CORRIGENDUM

Reference Tender No. Col/DC/228/01/2018 dated 14 June 2020 for Construction of 3200 Sanitation units/ Toilets in Batticaloa District.

Annexure – A : Amended BoQ

Annexure – B : Amended Drawing

Sanitary Unit Details

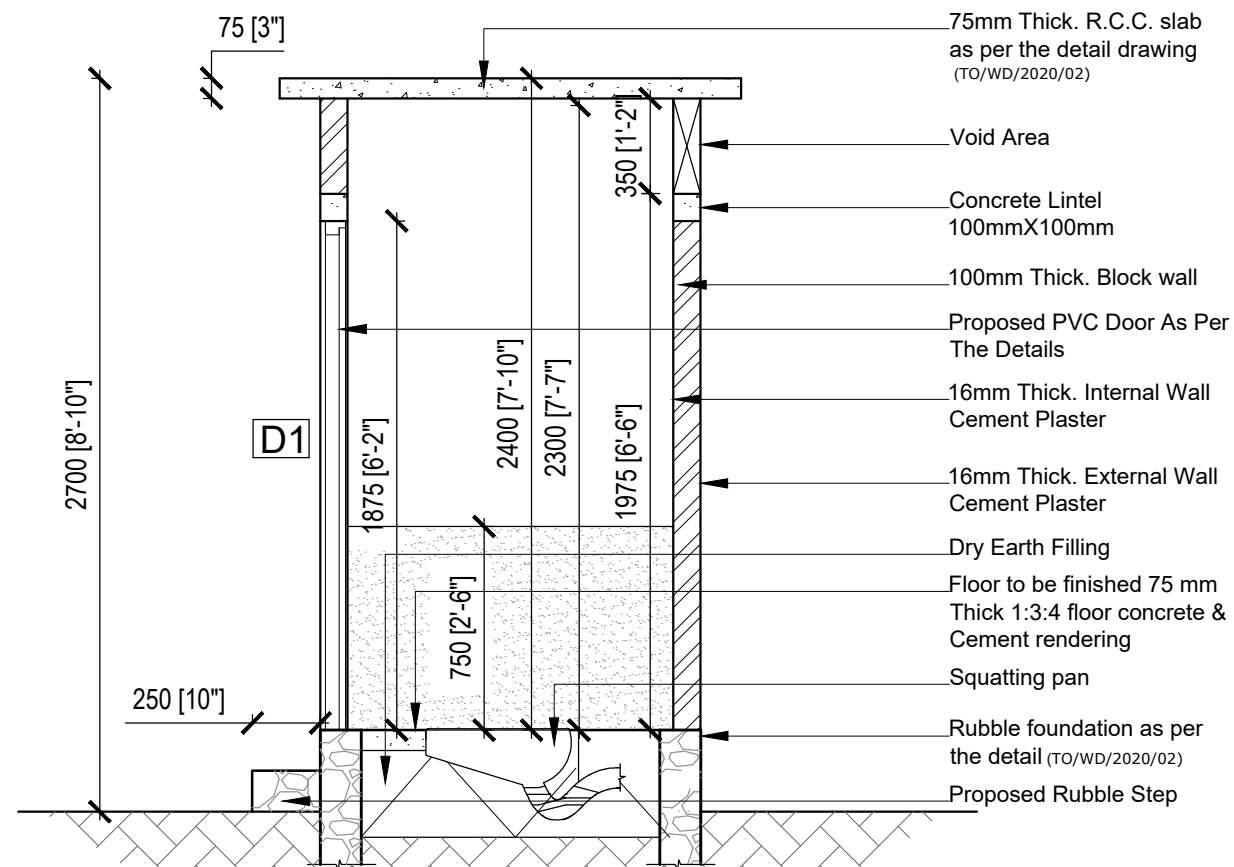
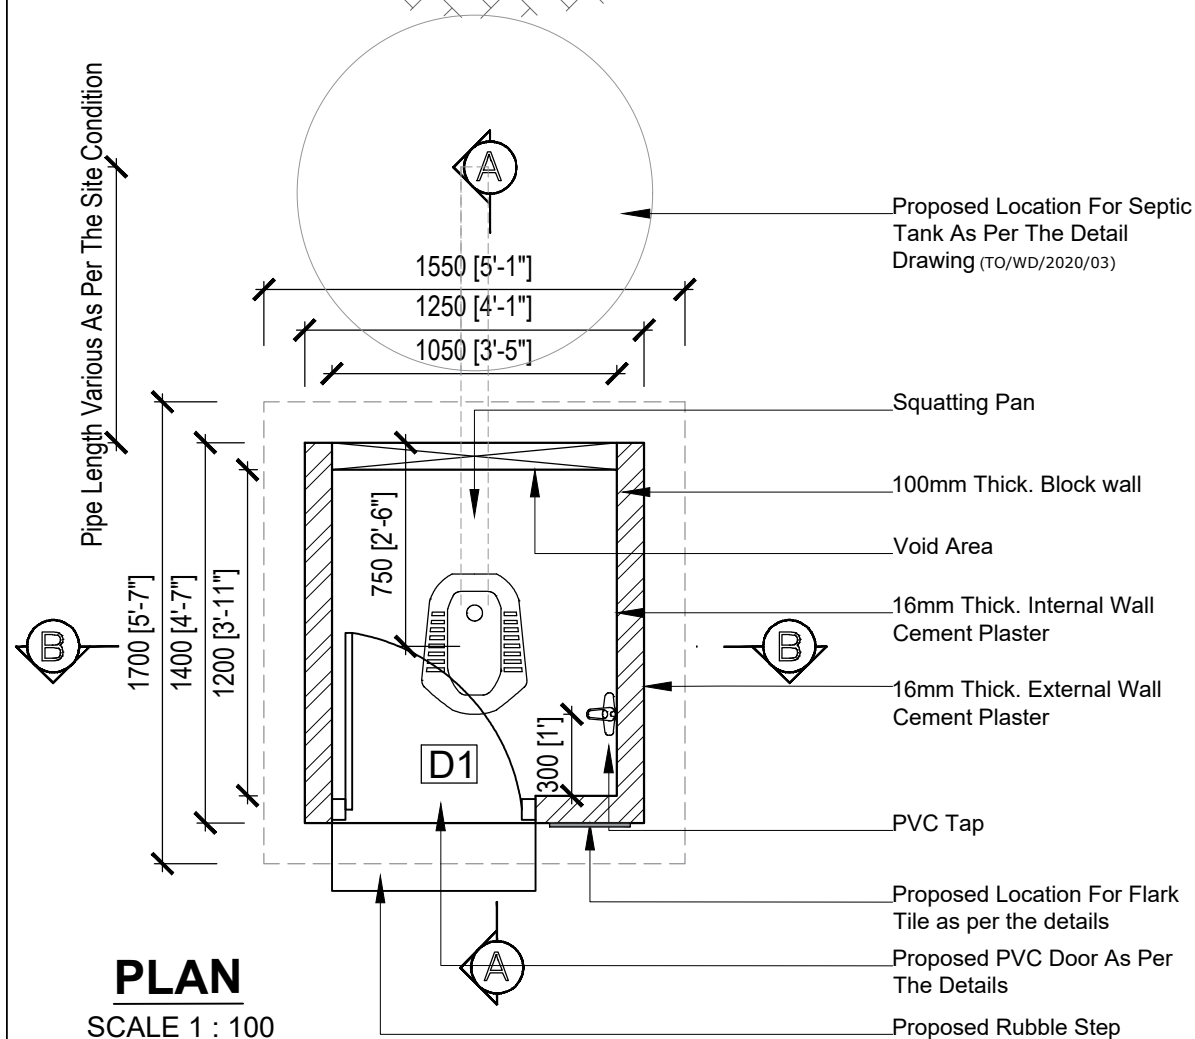
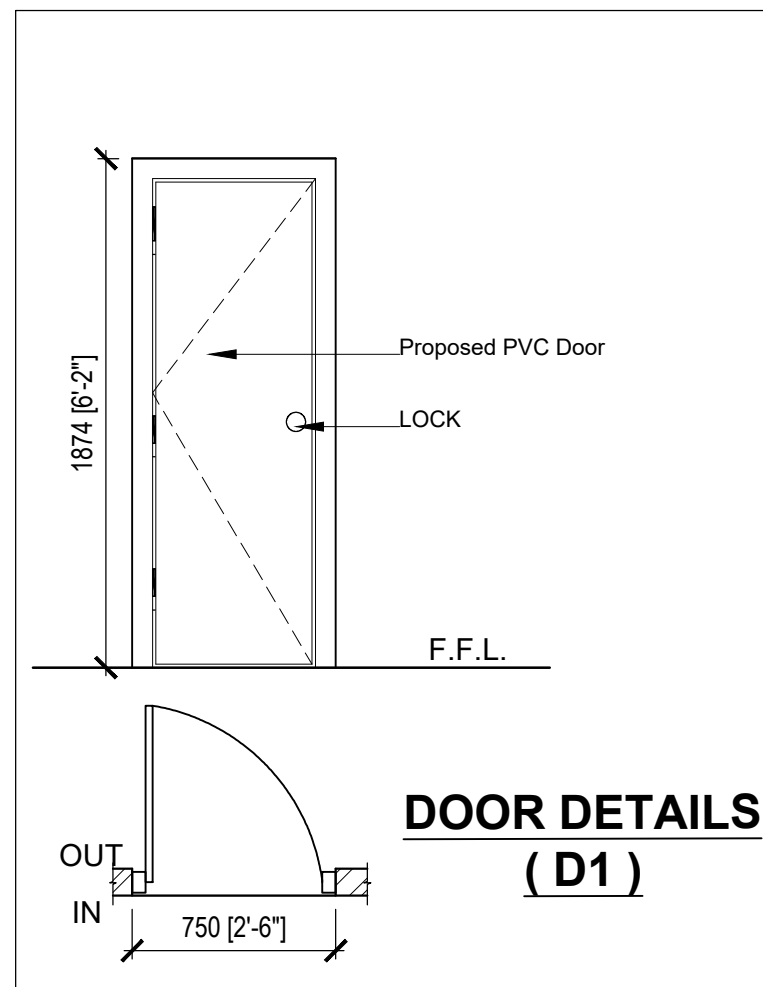
| No | Item No | Page No | Queries, Clarification & Answers |
|----|------------------|---------|--|
| 1 | BoQ Item No : 06 | 19 | Units & Quantity? <i>Units - Sqr.meter , Quantity - 1.50 (Please refer the Amended BoQ Annexure – A and Amended Drawing Annexure – B)</i> |
| 3 | BoQ Item No : 10 | 19 | Specification for the type of door to be installed? <i>Door type – PVC door Please refer the Amended BoQ Annexure – A and Amended Drawing Annexure – B</i> |
| 6 | | | Wall height of the toilet? <i>Please refer the Amended Drawing Annexure – B)</i> |
| 9 | | | The roof beam & the plinth beam is present in the drawing, whereas not in the BoQ?? <i>(Please refer the Amended BoQ Annexure – A and Amended Drawing Annexure – B</i> |

R.C.C. Slab detail & Foundation details

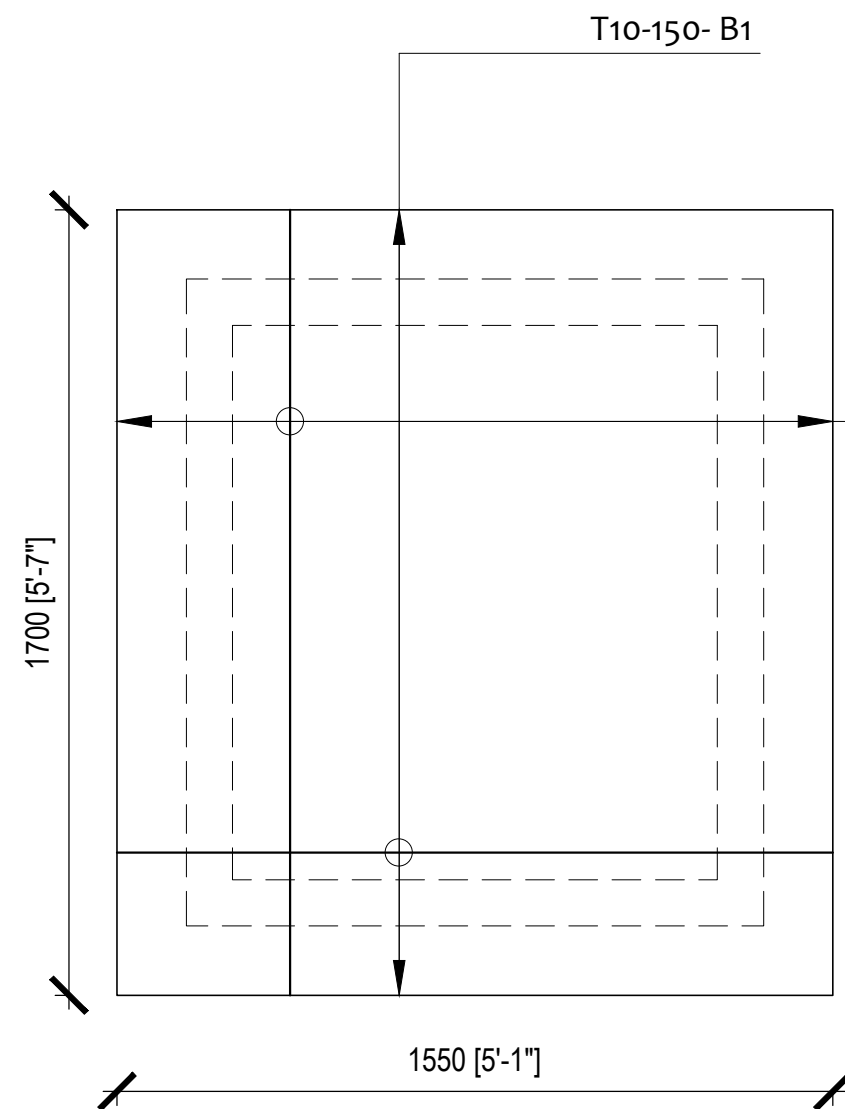
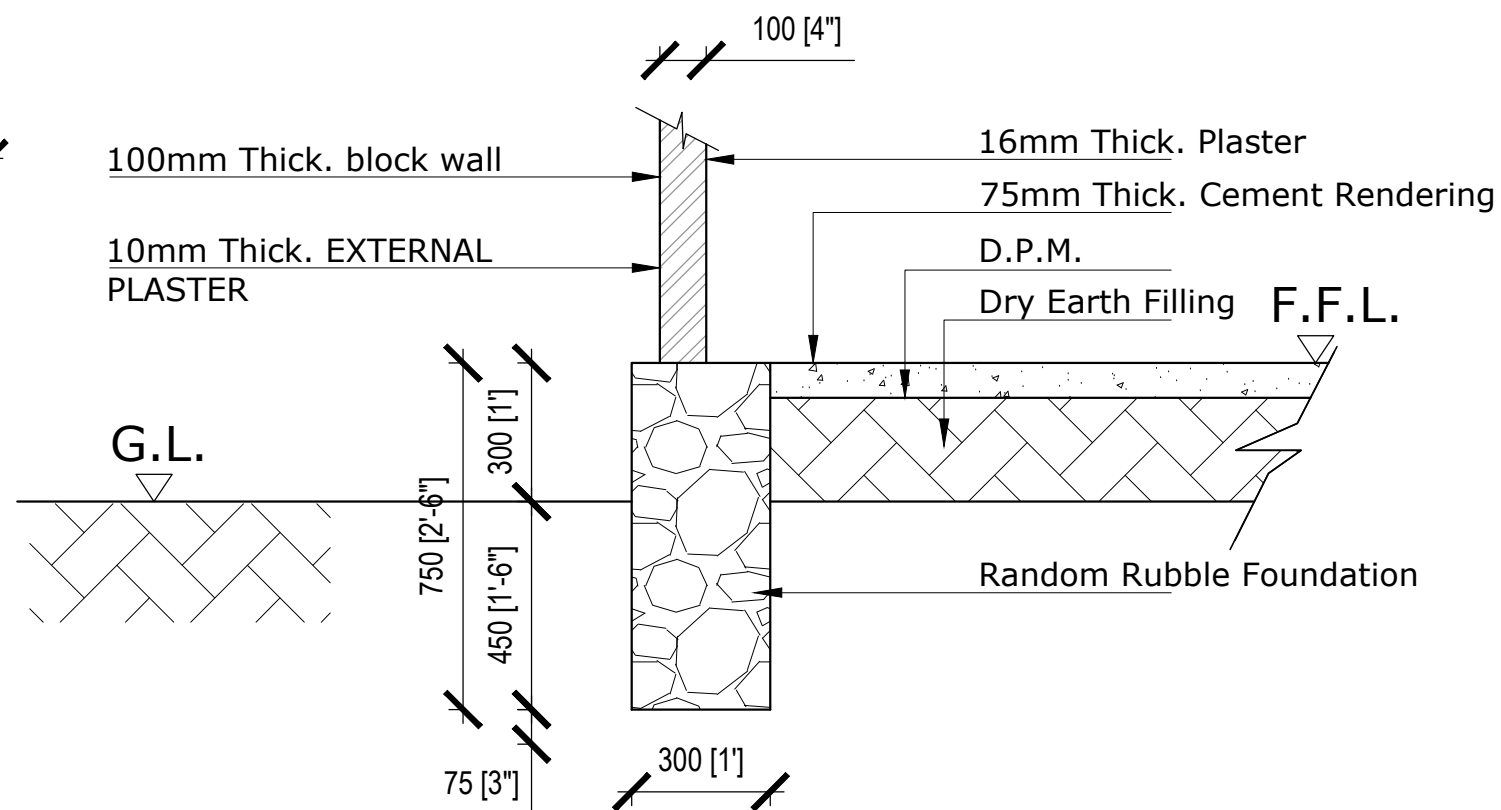
| No | Item No | Page No | Queries, Clarification & Answers |
|----|------------------|---------|--|
| 4 | BoQ Item No : 11 | 19 | Thickness of cover slab? <i>75 mm (Please refer the Amended BoQ Annexure – A and Amended Drawing Annexure – B)</i> |
| 7 | | | Reinforcement details of roof? <i>Please refer the Amended Drawing Annexure – B</i> |

DRAWING TITLE
SEPTIC TANK & SOAKAGE PIT

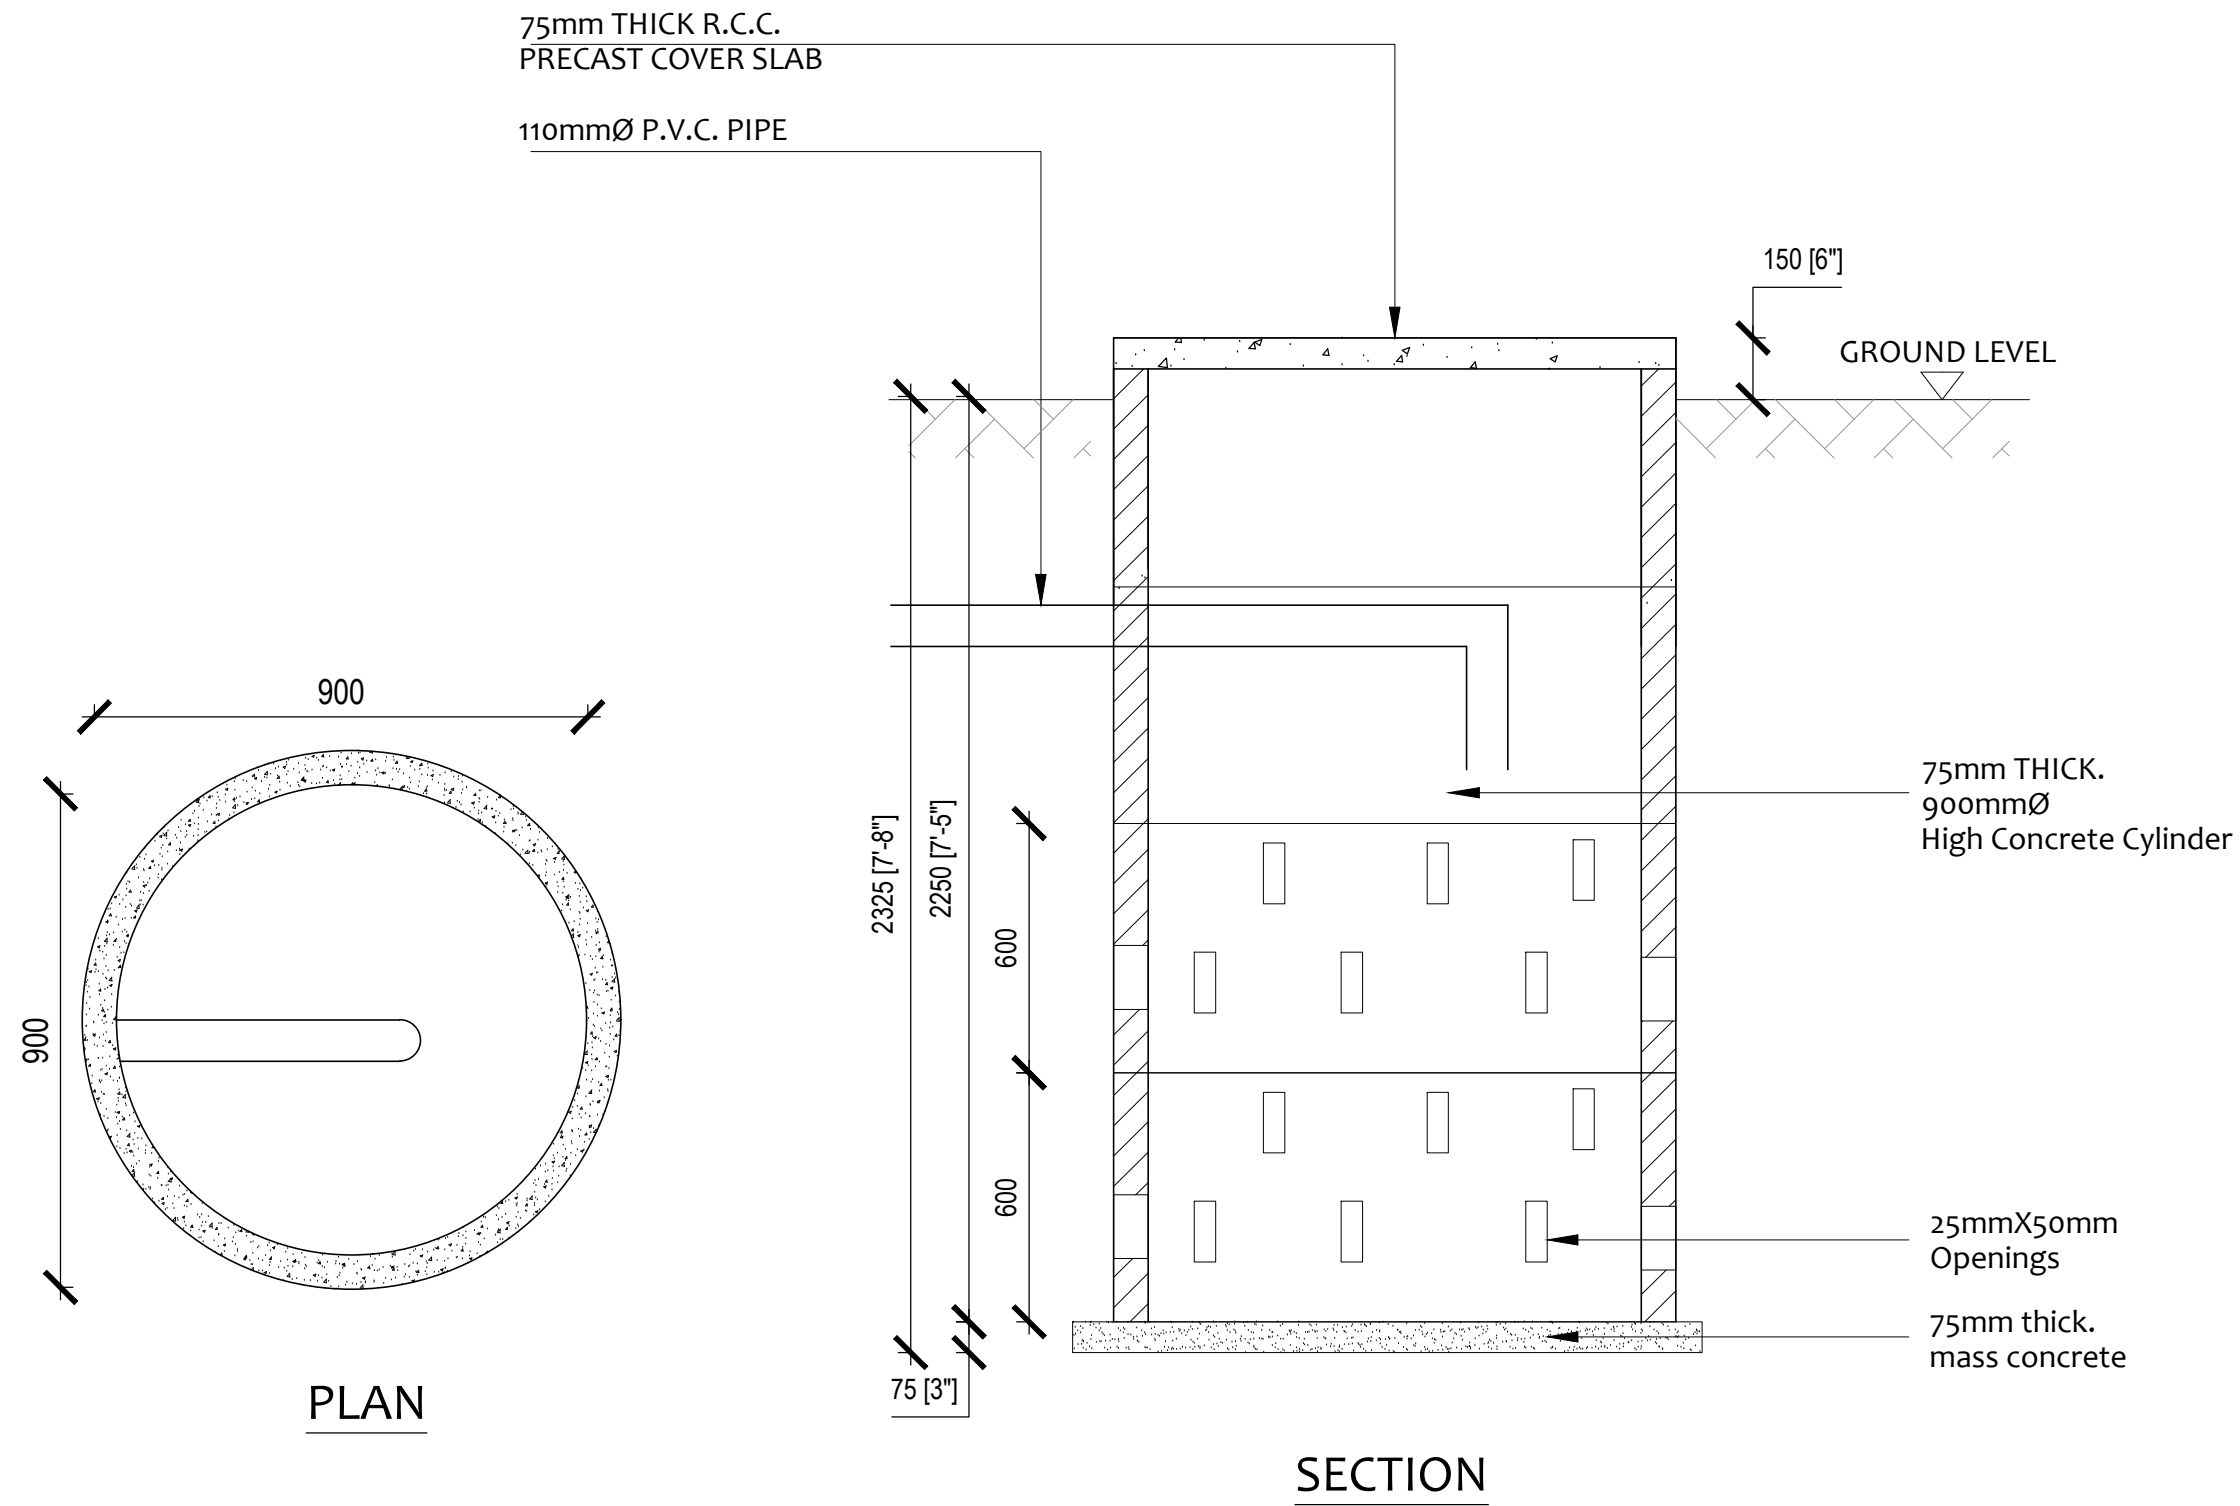
| No | Item No | Page No | Queries, Clarification & Answers |
|----|------------------|---------|--|
| 8 | | | Details of Septic Tank? <i>Please refer the Amended Drawing Annexure – B</i> |
